UNITED STATES PATENT AND TRADEMARK OFFICE

APPLICATION NO.	FILING DATE	FIRST NAMED INVENTOR	ATTORNEY DOCKET NO.	CONFIRMATION NO.
10/622,436	07/18/2003	Josef Ruppert	8178	4973

Office Action Summary

DETAILED ACTION

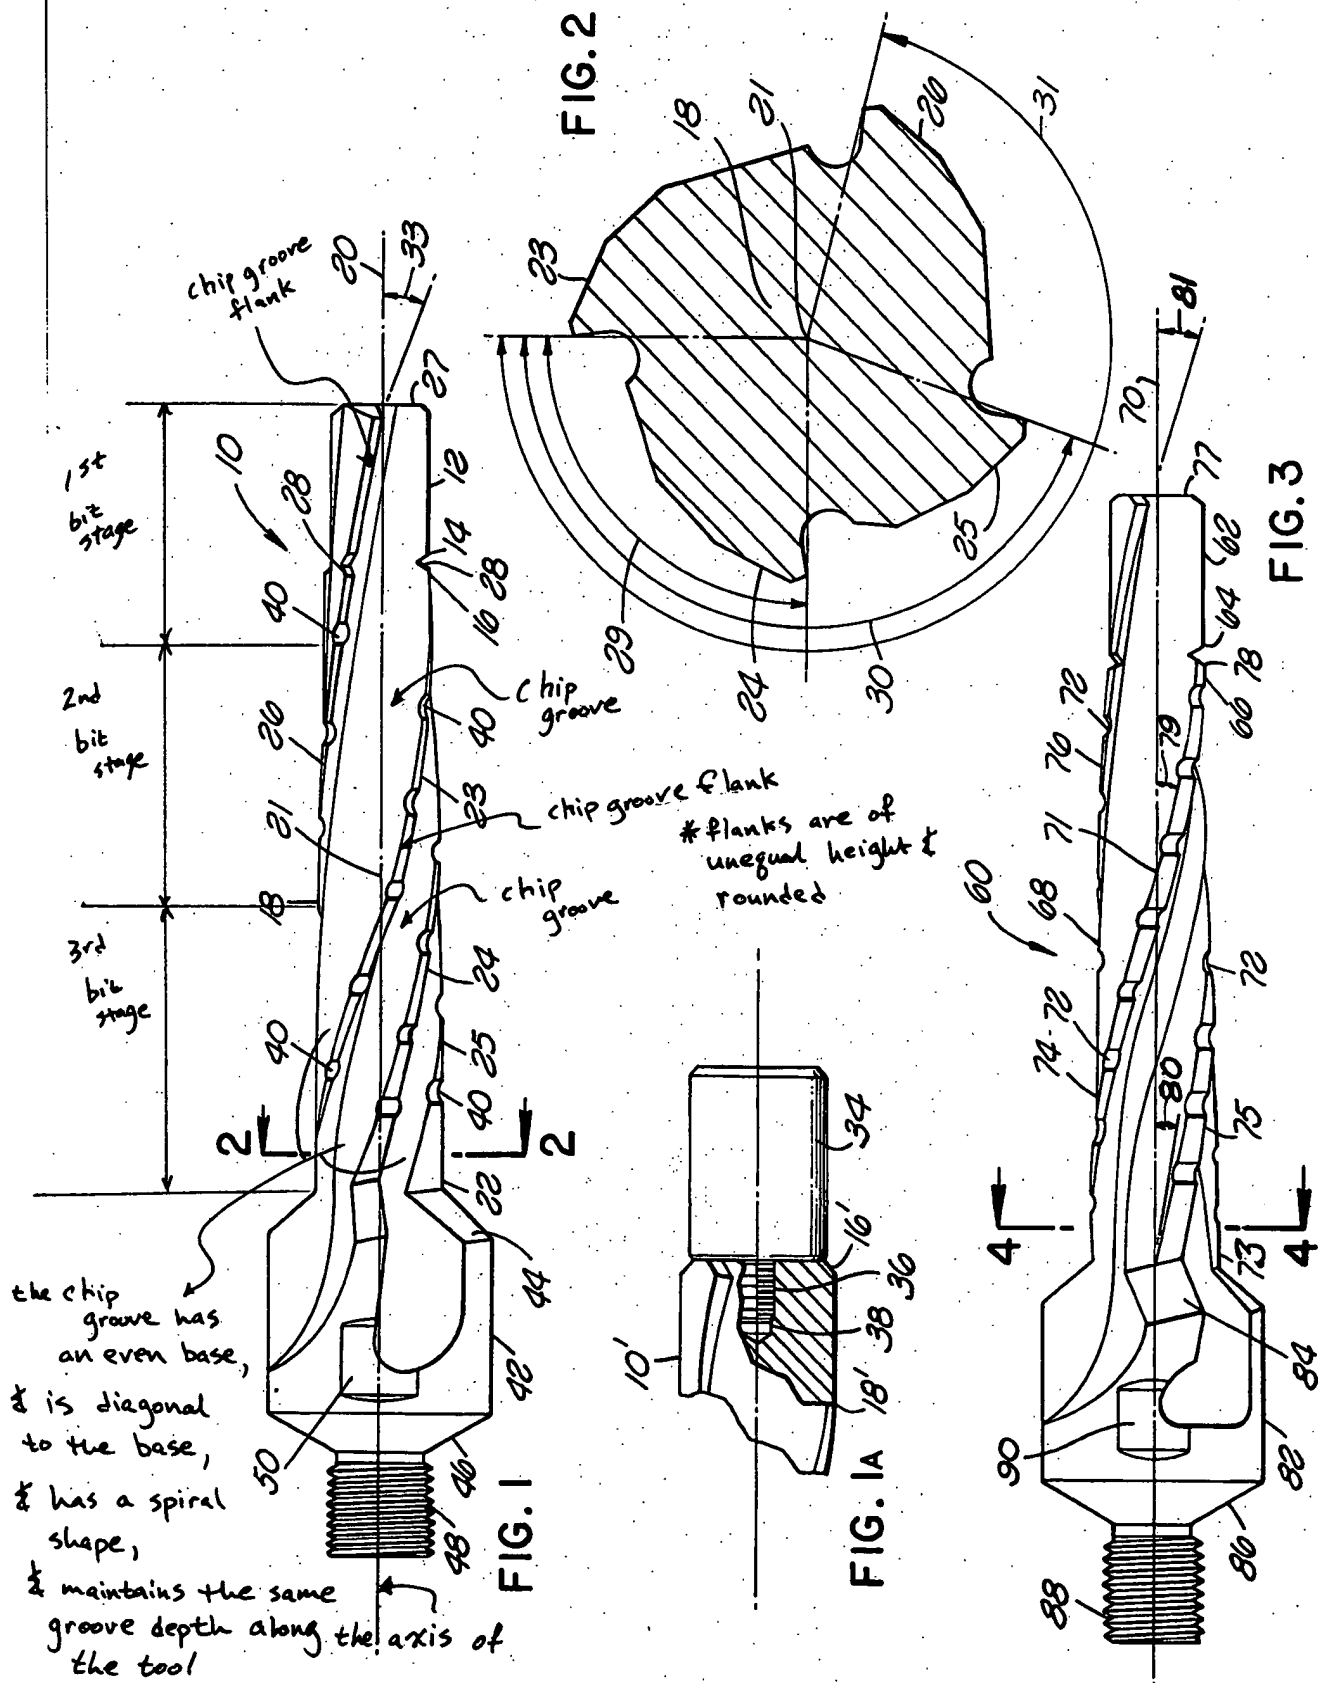
Arnold discloses a drilling tool (10) with a chip groove (see drawing attachment, fig.1), a first bit stage designed as a core bit (defined by reference numeral 27), and at least one second bit stage (see drawing attachment, fig.1) arranged in the form of a step (the step form is defined by the varying diameters of the different bit stages, which is more clearly seen in fig. 5). All of the bit stages have at least one common chip groove as seen in the drawing attachment, fig.1. The chip groove is also defined by the chip flutes 23, 26 and has an even base with the course of the chip groove having a spiral shape (see drawing attachment, fig.1). The chip groove also has flanks (defined by the right and left edges of the groove, which is also defined by the chip flutes 23, 26). The flanks are of unequal height (see drawing attachment, fig.1); the left edge of the chip groove is higher than the right edge of the chip groove). The flanks of the chip groove are in a diagonal orientation with respect to the groove base (see drawing attachment, fig.1), and the flanks have a rounded shape about the central axis 20 (see drawing attachment, fig.1). The path of the chip groove increases in diameter through the successive bit stages as can be seen in the drawing attachment, fig.1 (the increase in diameter can be more clearly seen in fig. 5), which forms an imaginary cone (the imaginary cone is defined by the tool having a cone shape as seen in figs.1, 5 of the drawing attachment). The depth of the chip groove has virtually the same depth throughout the bit stages as can be seen in fig.1 of the drawing attachment; the chip groove having the same depth throughout the tool can also be seen in fig. 2 of the drawing attachment.
